# CAPITAL EXPENDITURE DESCRIPTION – DETAIL

## DEPARTMENT/BOARD – LINCOLN PUBLIC LIBRARY

Project/Expenditure: Elevator smoke vent Fiscal Year: 2008 Cost: \$20,000  
 Department Head: Barbara Myles, Director Priority: # 2 of 2

To: Building Committee  
From: Barbara Myles  
Date: 9/5/2006  
Subject: Capital Plan FY 2008 Budget - Smoke vent upgrade

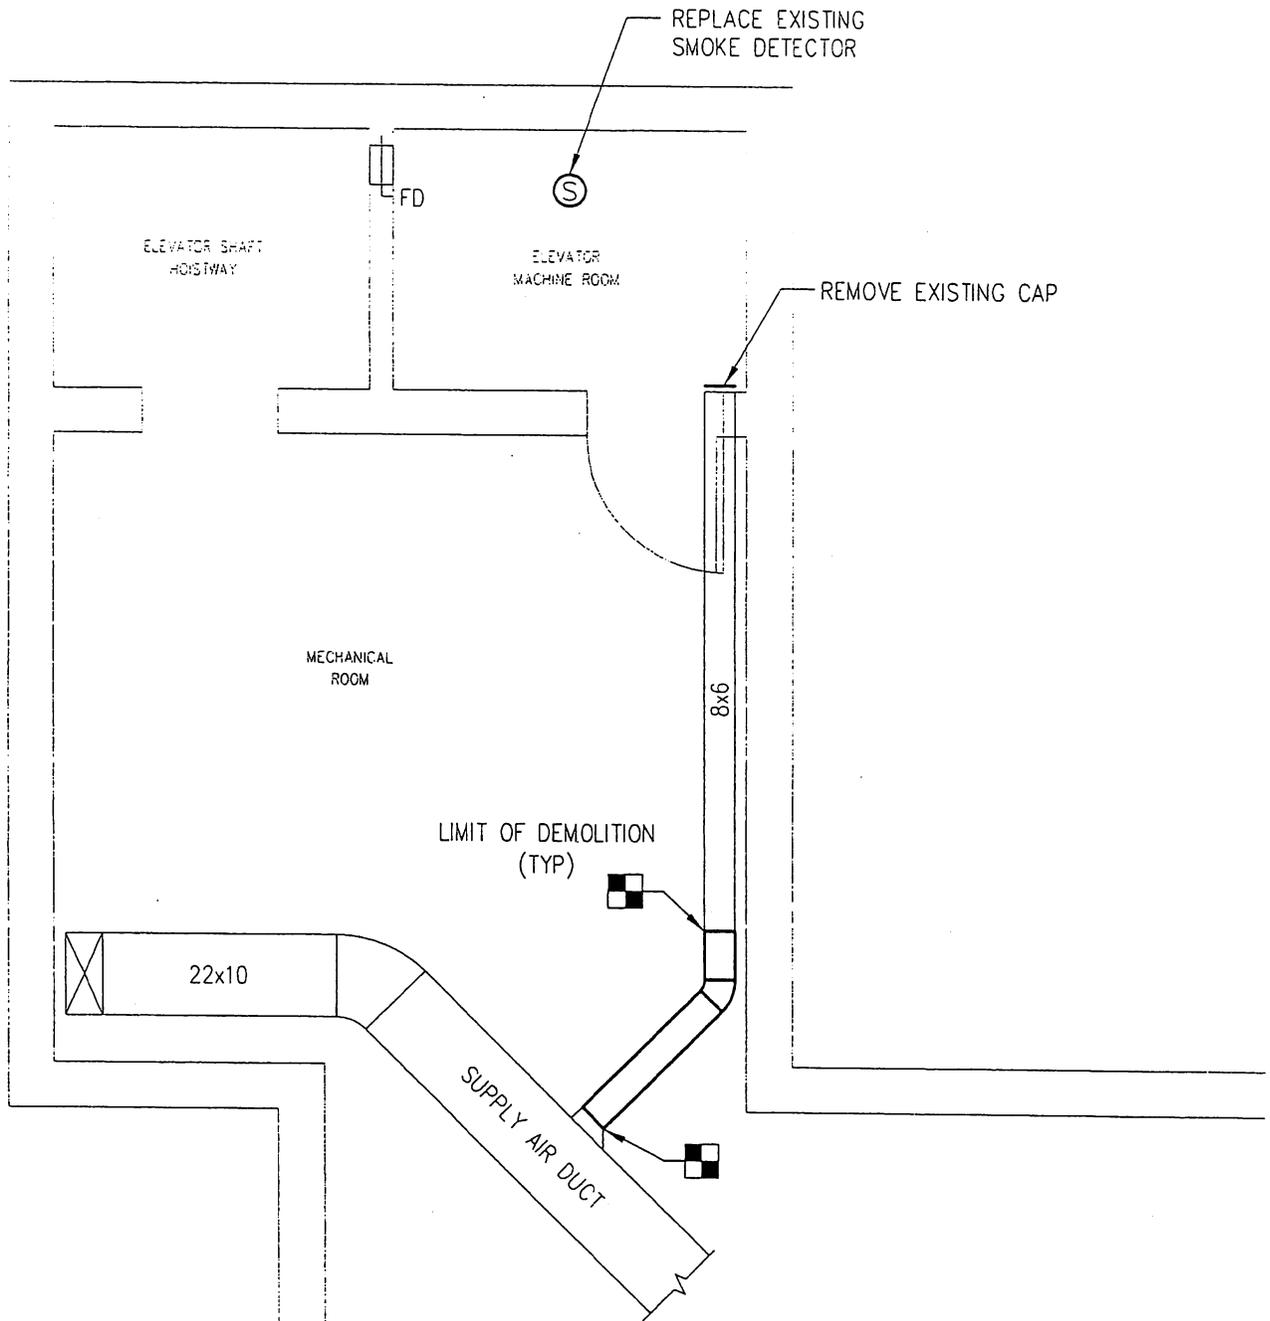
1) Sketch number 1 shows demolition to the existing HVAC duct work. It

looks like the duct that connects the elevator room to the supply air duct is blocked off. Sketches 2 and 3 show the plan to move one end of the duct from the supply air duct and to the exhaust air duct.

Can you explain why this change is necessary? Was the original design incorrect?

1. The original design was OK for the time of installation, but the codes for elevator machine room ventilation (actually exhaust) have indeed changed. The current sketches show the room being provided with the current code mandated exhaust (and make-up air via transfer).
2. I'll need to spend a little time to come up with a cost estimate...I'll try to get at this early next week and get it to you as soon as possible.
3. I'd need to dig further to determine if the existing vent was adequate for the time of installation, it definitely doesn't meet current codes, however. I believe it is up to the individual elevator inspector's as to whether they continue to allow currently non-compliant vents (i.e. grandfather them).

TOP OF ELEVATOR SHAFT HOISTWAY / ROOF PLAN  
MECHANICAL / ELECTRICAL DEMOLITION

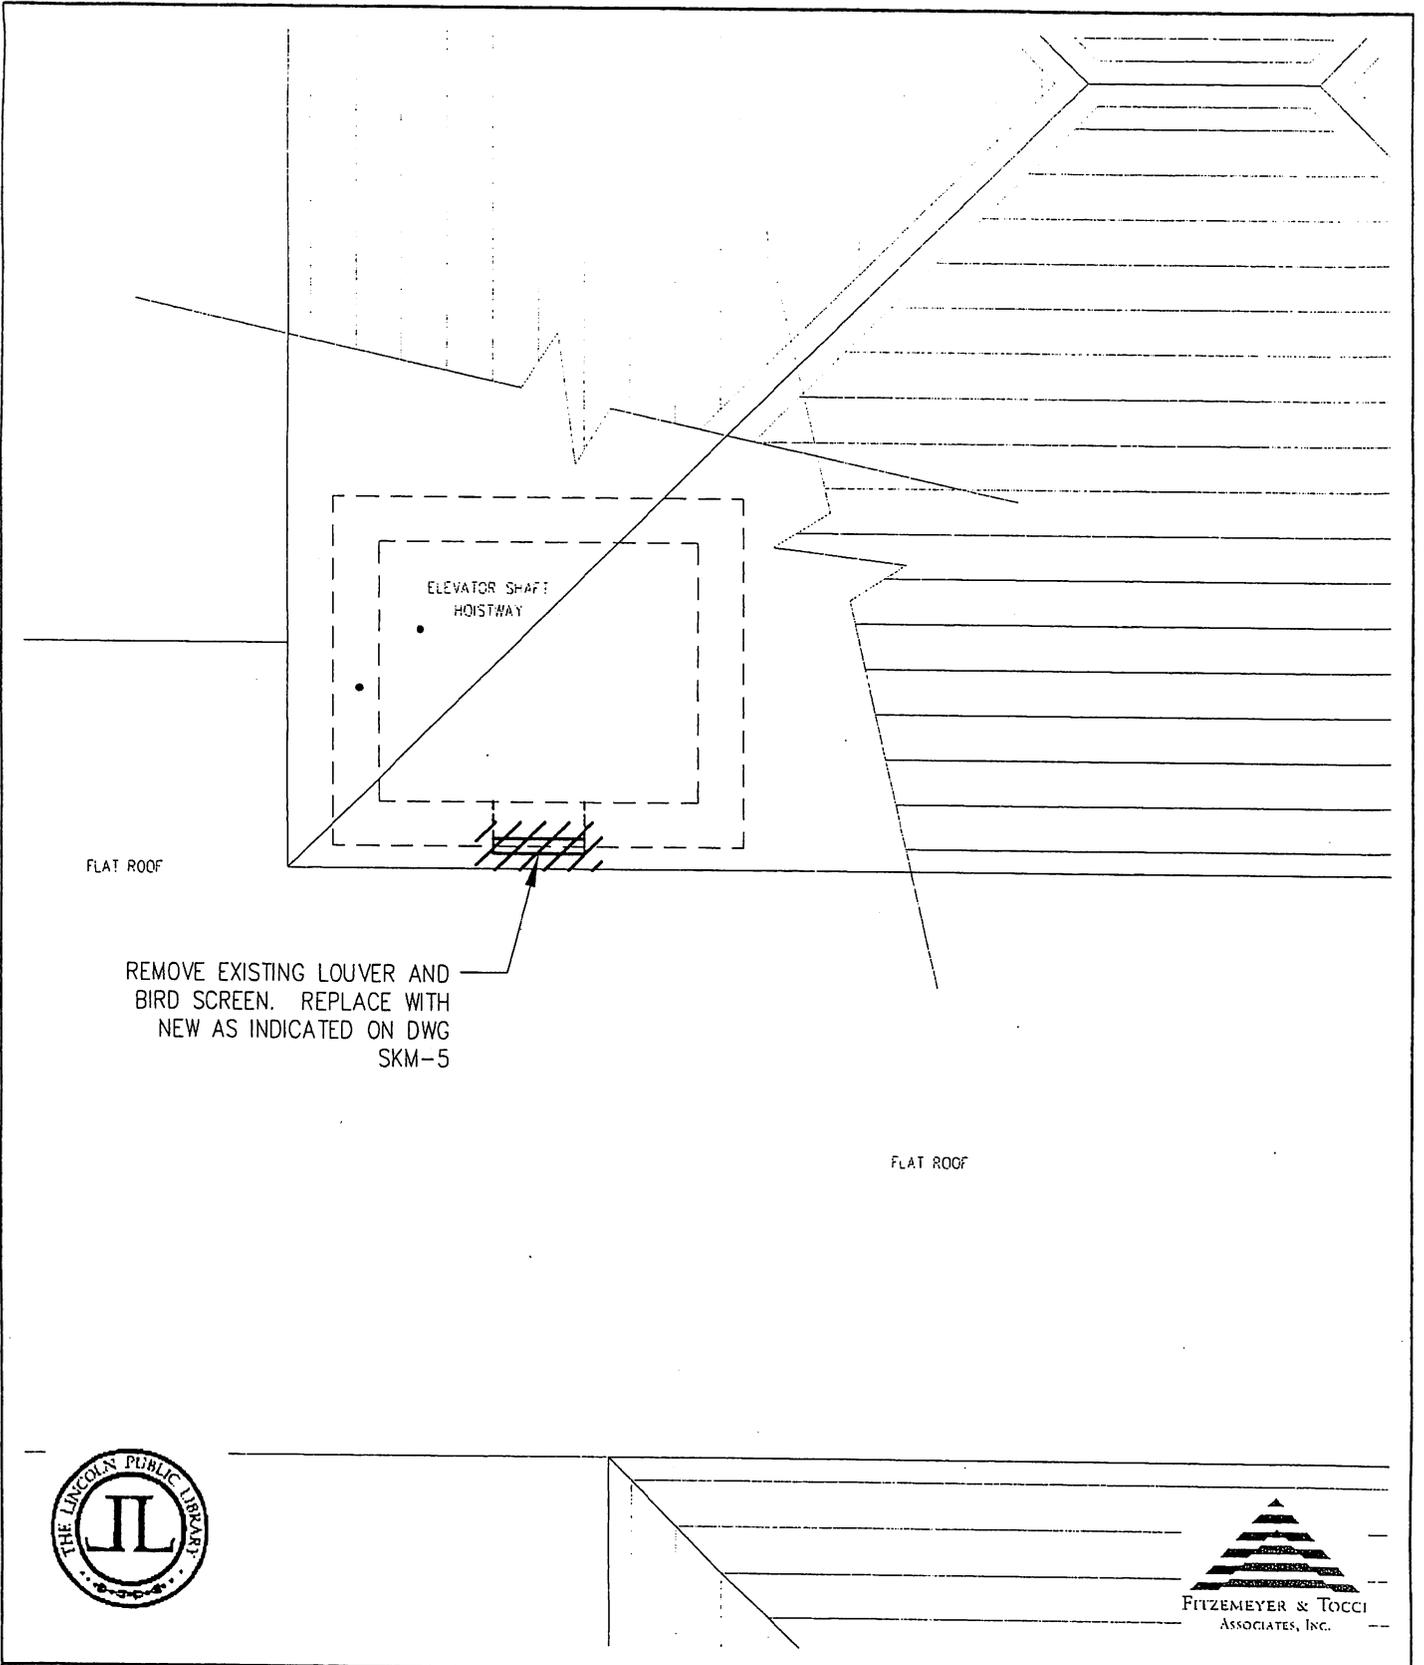
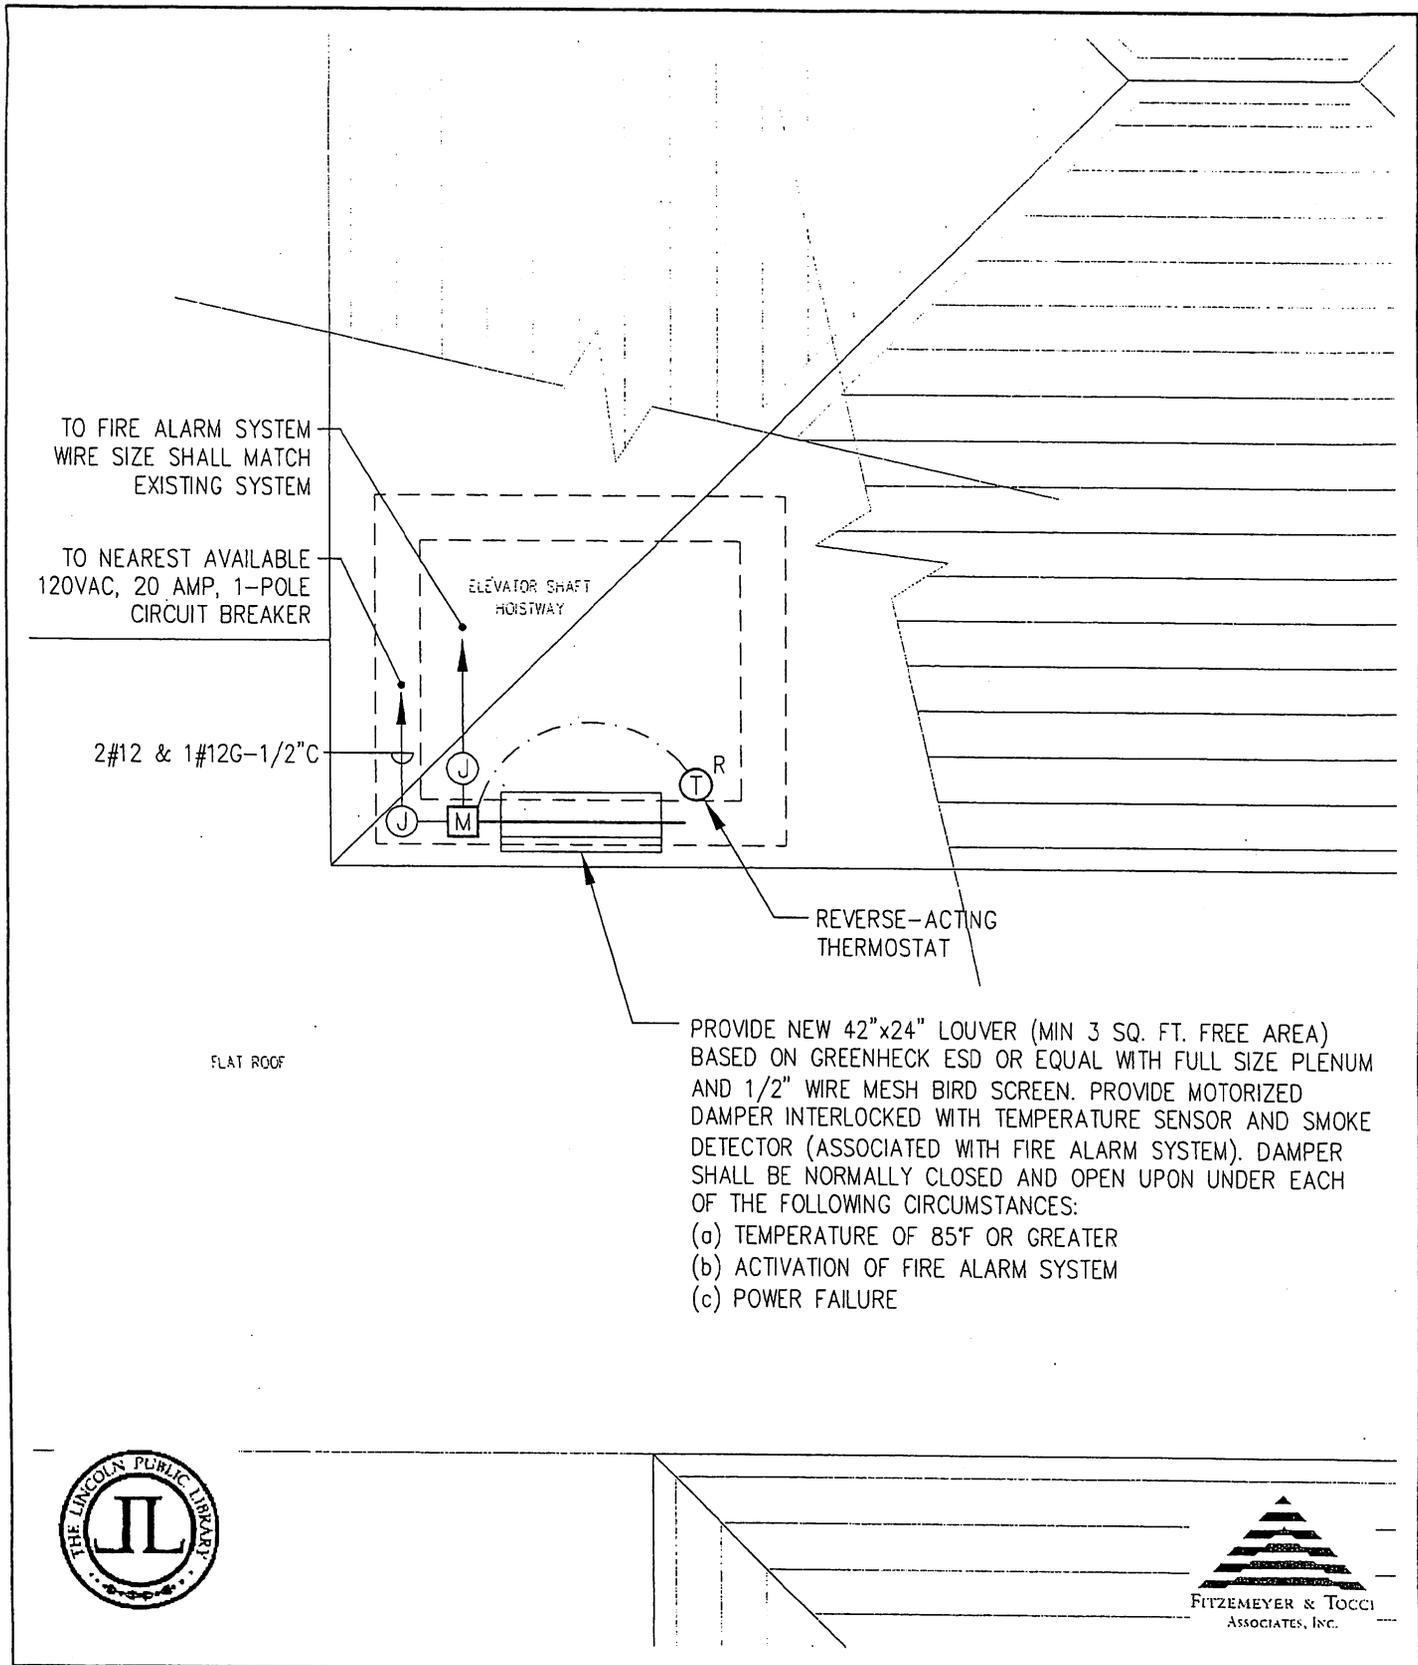
REMOVE EXISTING LOUVER AND  
BIRD SCREEN. REPLACE WITH  
NEW AS INDICATED ON DWG  
SKM-5

3) Sketches 4 and 5 show the size of the existing vent increasing substantially. I understand that we need to meet current building code requirements but can you tell me if the existing vent, which was installed in 1989, met the building code for 1989? If the vent did not meet 1989 building code, I have the chance to fast track this project.
